Project: 407 E. Monroe Austin, TX 78704

# 407 E. Monroe

**HR-2022-070860/2022-065132 PR**

**Cost Prohibitive Rehabilitation**

## Exhibit 5

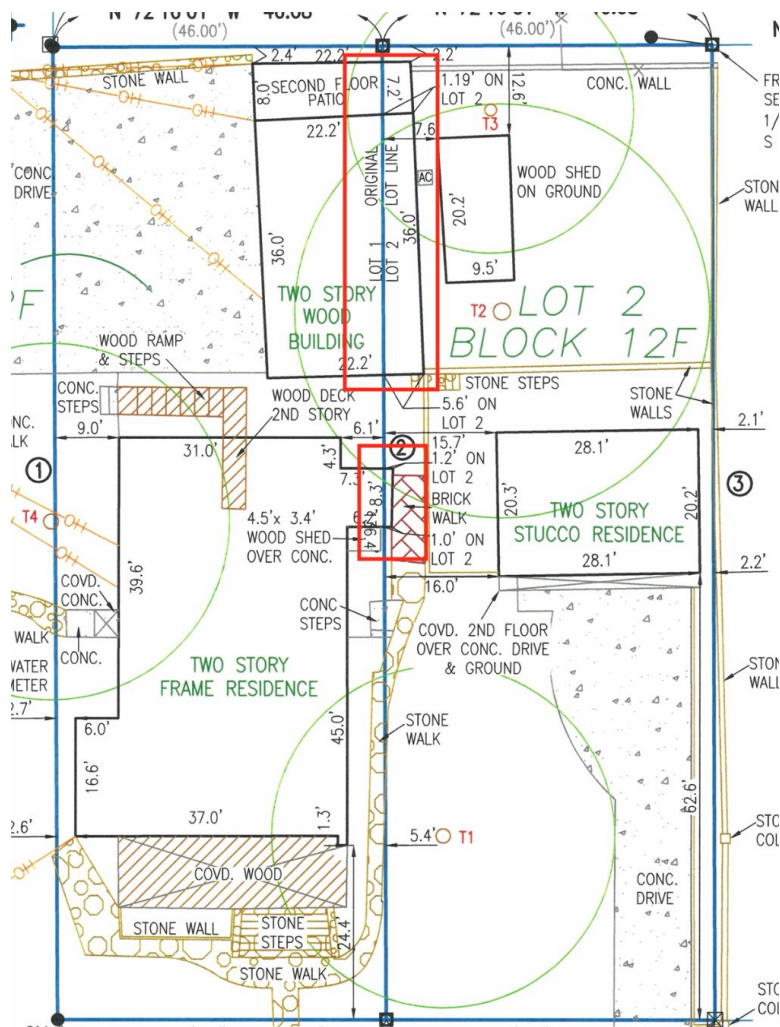
Figure 1: 2x4 roof framing at 24", 2x4 ridge beam, and 2x4 hip beam, note lack of vertical support at hip to ridge connection.

Figure 2: 2x8 floor framing at 16".

Figure 3: Rear wall, SW corner, sand bags, and soil built up above bottom plate.

Figure 4: Rotting soffit and crack stucco veneer on rear wall
